Access Compliance Report

Public Rights-of-Way

(Curb Ramps)

| Intersection ID: 10019914 | Main Street: ARDREY_KELL_RD | Cross Street: N/A | Location: NW |

| ADA ID: 8C2EEA7BF543 | Ramp Type: Perp | Initial Pass/Fail: Fail | Overall Compliance: No |

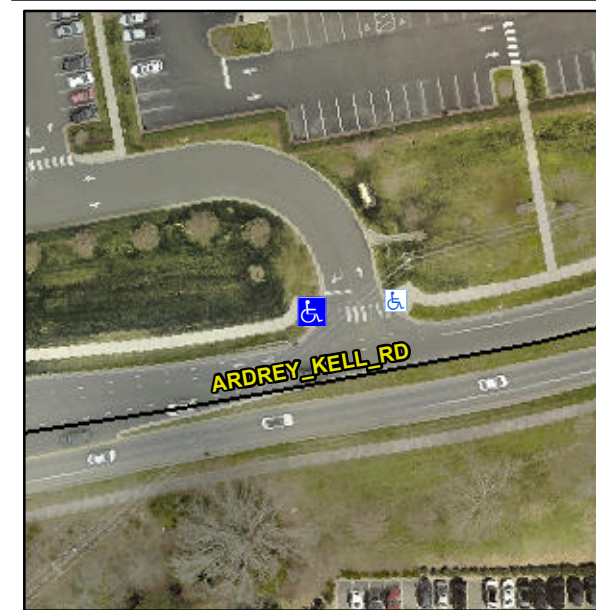
Possible Solutions:

Remove & Replace Entire Ramp.

Not Found, R304.5.3

| Compliance | Description | Data | Compliance | Description | Data |
|------------|-----------------------|------|------------|-----------------------------|------|
| Yes | Ramp Width (in) | 48.0 | No | Ramp XSlope (%) | 6.7 |
